MECKLENBURG COUNTY
DEPARTMENT OF ENVIRONMENTAL HEALTH

APPLICATION FOR SOIL INVESTIGATION

APPENDIX H
SITE EVALUATION
(Ground Absorption Sewage Disposal)

SITE INVESTIGATION REPORT
INDIVIDUAL SEPTIC TANK SYSTEM
WITH SUBSURFACE,
SOIL ABSORPTION,
EFFLUENT DISCHARGE

* See Diagram on Back (Include: Soil areas, property lines, roads, streams, gullies, wet areas, fill areas, wells, water bodies, slope patterns, etc.)

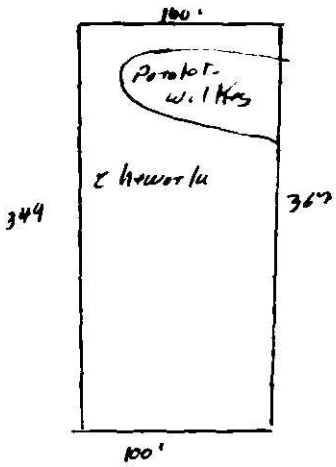
FACTORS	AREA 1	AREA 2	AREA 3	AREA 4
1. SLOPE (%)	S PS — U	S PS 6-15% U	S PS U	S PS U
2. SOIL TEXTURE (12-36 in.) (Sandy, loamy, clayey, Note 4:1 clay)	S PS — U	S PS clay U	S PS U	S PS U
3. SOIL STRUCTURE (12-36 in.) (Clayey soils)	S PS — U	S PS Blocky U	S PS U	S PS U
4. SOIL DEPTH (In.)	S PS — U	S 48" PS U	S PS U	S PS U
5. RESTRICTIVE HORIZONS (In.) (Impervious Strata, rock)	S PS — U	S Mass of saprolite at 30" PS U	S PS U	S PS U
6. SOIL DRAINAGE/GROUNDWATER (External & Internal)	S Poorly drained PS Perched high water U Table	S 72" PS Water U Table	S PS U	S PS U
7. SOIL PERMEABILITY (Percolation Rate)	S subject to PS Flooding U	S Slow 72" PS min/in U	S PS U	S PS U
8. OTHER (Specify)	S PS U	S PS U	S PS U	S PS U
9. SITE CLASSIFICATION*	unsuitable	unsuitable		
SOIL SERIES	Chewacla	Pacolet-w. Mas Zuttergrade

Recommendations/Comments: Based on this investigation, the soils on the lot were found to be unsuitable for the installation of a septic tank system.
